RE: CERTIFICATION FOR ST. JOSEPH'S HOSPITAL COMPLEX  
SLOPE EROSION CONTROL PORTION  
(K-15/D6) ENGINEER'S STAMP DATED MARCH 8, 1989

PROJECT TITLE: St. Joseph's Hospital Complex ZONE ATLAS/DRNG. FILE #: J-K-15-Z

1. The Drainage/Grading Plan and Drainage Report can be approved for Preliminary Plat when the following inconsistency is resolved:
  - a. On the previously approved Conceptual Drainage Plan the storm drain size in Marquette street to Roma Ave. is shown as a 24" diameter. The design calculations on the "Existing Conditions" drawing also show it as 24" RCP. Your new submittal show the existing storm drain size as 12" diameter and 15" diameter. Field verify the existing storm drain size, and if it is not 24" dia. as assumed by our previous approval, then additional storm drain improvements, will be required unless new design calculations can show that the existing storm drain has adequate capacity.

RE: CONCEPTUAL DRAINAGE MASTERPLAN FOR ST. JOSEPH HOSPITAL  
COMPLEX RECEIVED NOVEMBER 27, 1985 (K-15/D6)

| TITLE: ST. JOSEPH HOSPITAL COMPLEX<br>DRAINAGE / GRADING PLAN          |                    |

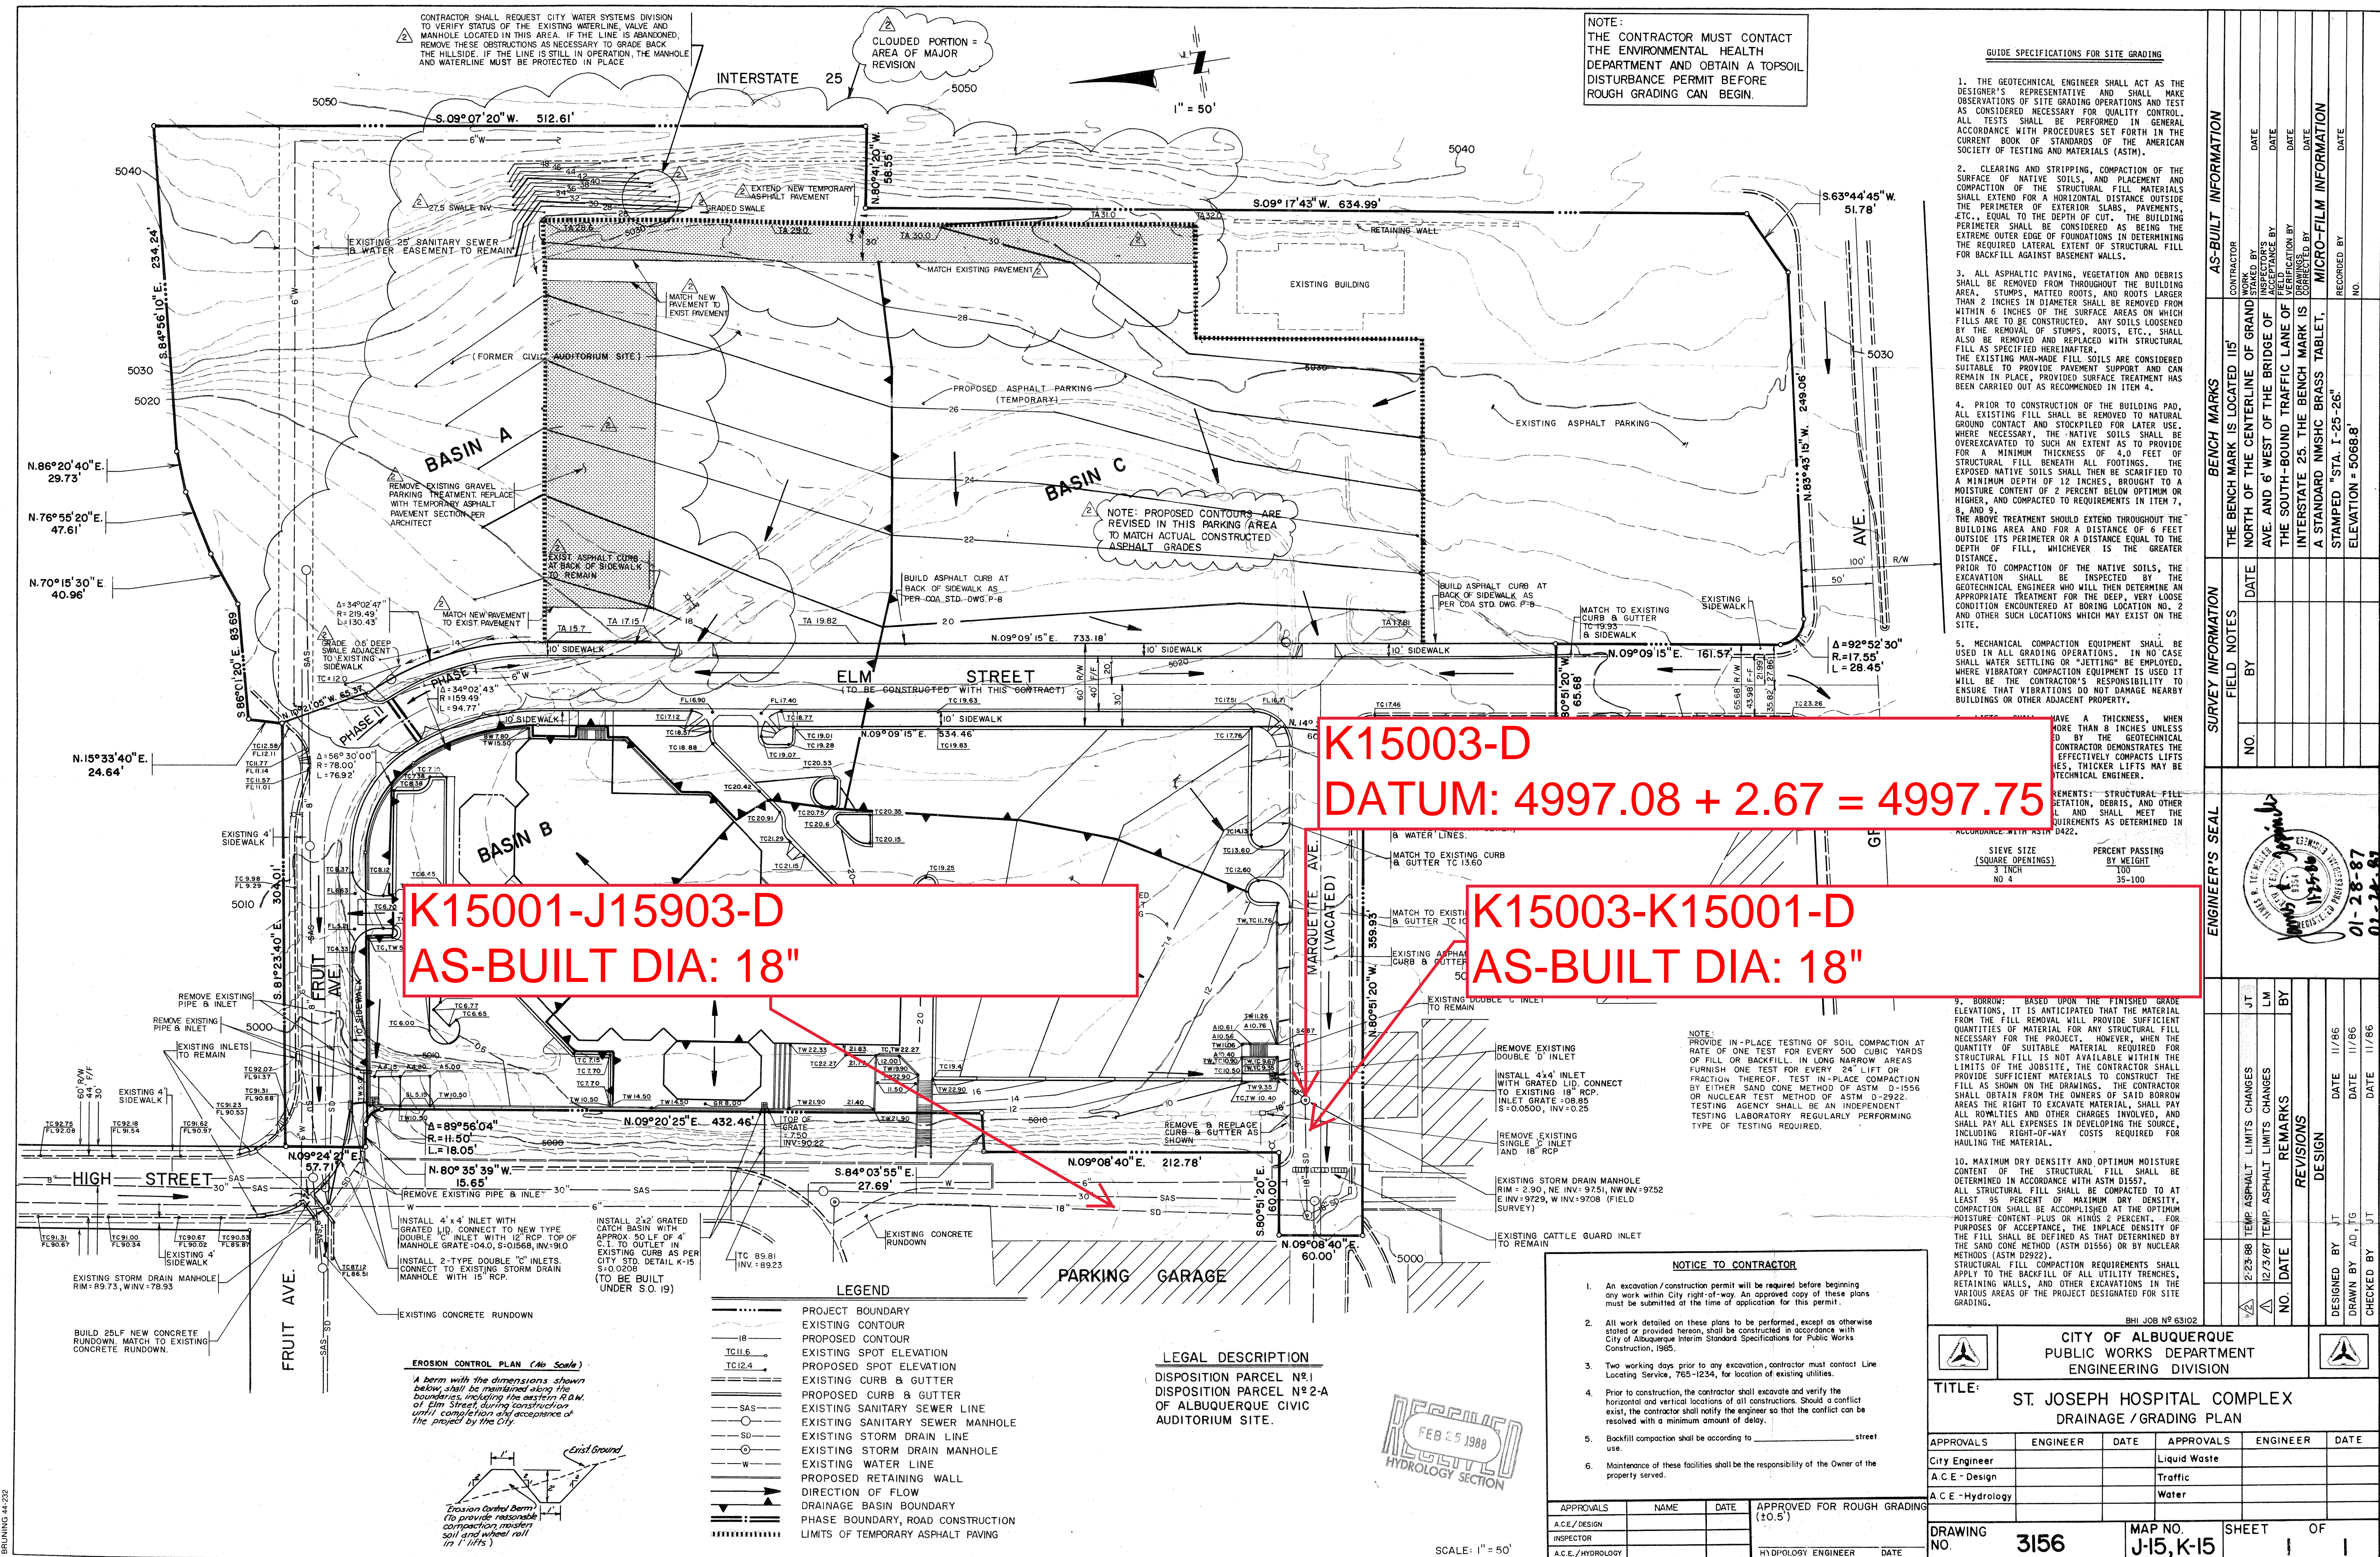
2. Before Grading/paving permit approval for the parking areas east of Elm Street, detailed plans are required showing spot elevations and exact limits for paving. Also show what treatment is proposed on the steep slope along the north edge of the existing parking area in Basin C. This parking area can be submitted and approved separate of the Building and Parking lot west of Elm Street.

3. Prior to Building approval by Hydrology the following items are required:
- a. An approved infrastructure listing from DRB for the required offsite street and drainage improvements.
  - b. Construction drawings submitted and reviewed at the DRC for the offsite street and drainage improvements.
  - c. Provide two copies of the Building Drainage Plan with the required S.O. #19 construction notes to contractor, with appropriate signature blocks since the catch basin and 6" outlet pipe to Roma Ave. requires a separate permit to construct private storm drain improvements within Public R.O.W. (S.O. #19). All the other storm drain improvements must be constructed under City Work order and should be identified as such on the Drainage Plan.

| Seal                                       | GRADING PLAN             |

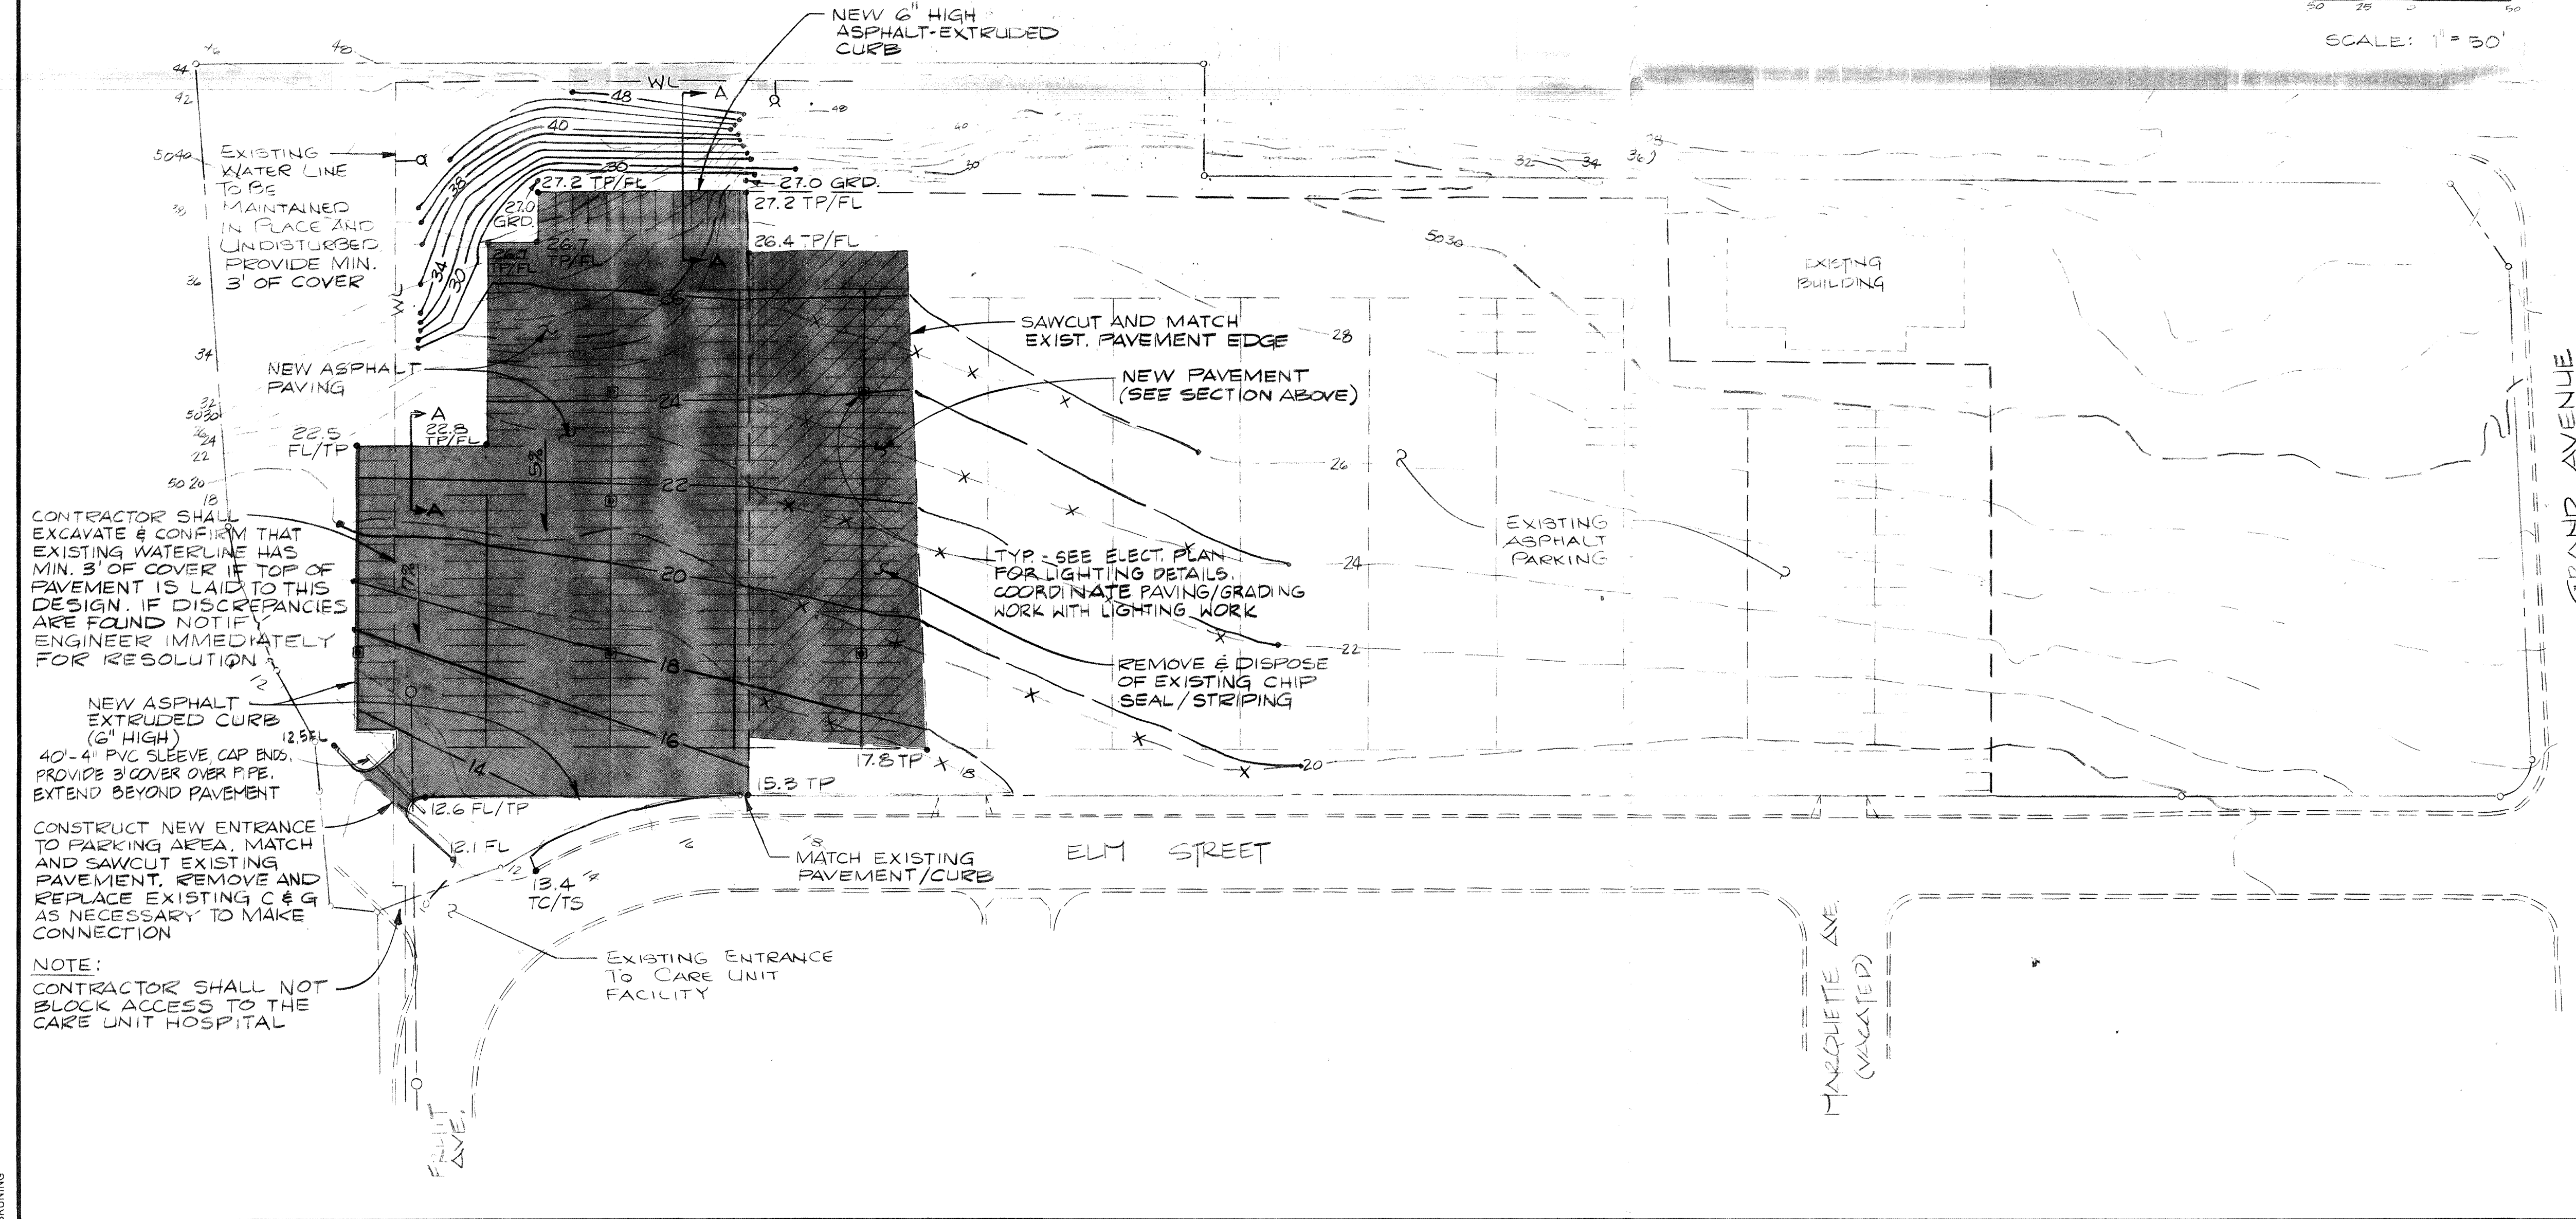
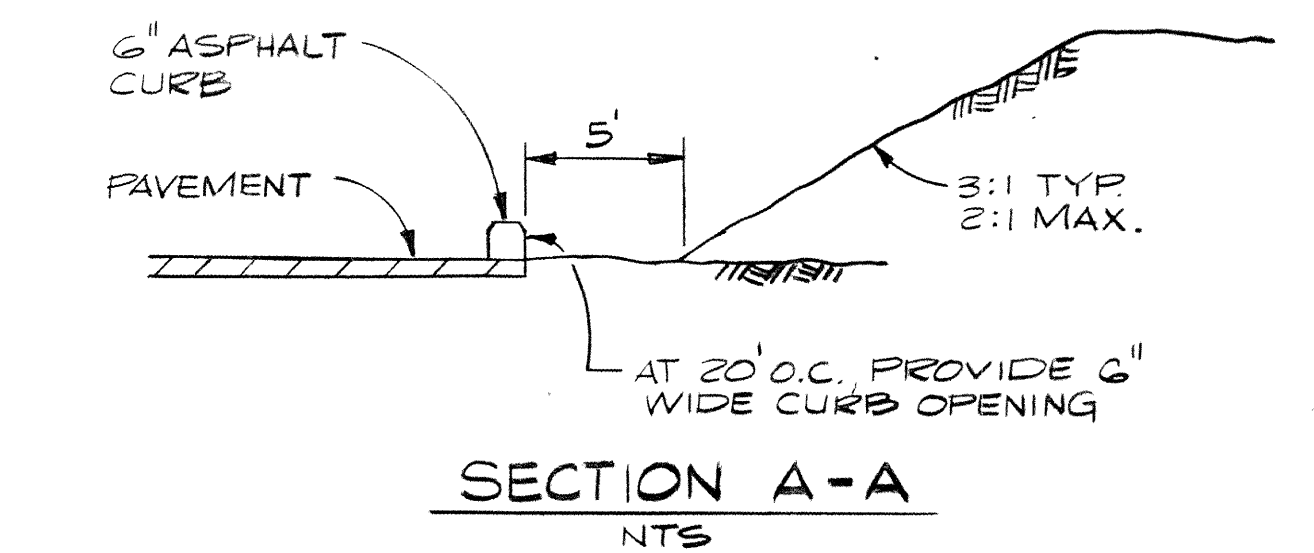
1. Please indicate an asphalt extruded curb all along the west perimeter of the parking lot.
2. Include your drainage calculations on the plan drawing.
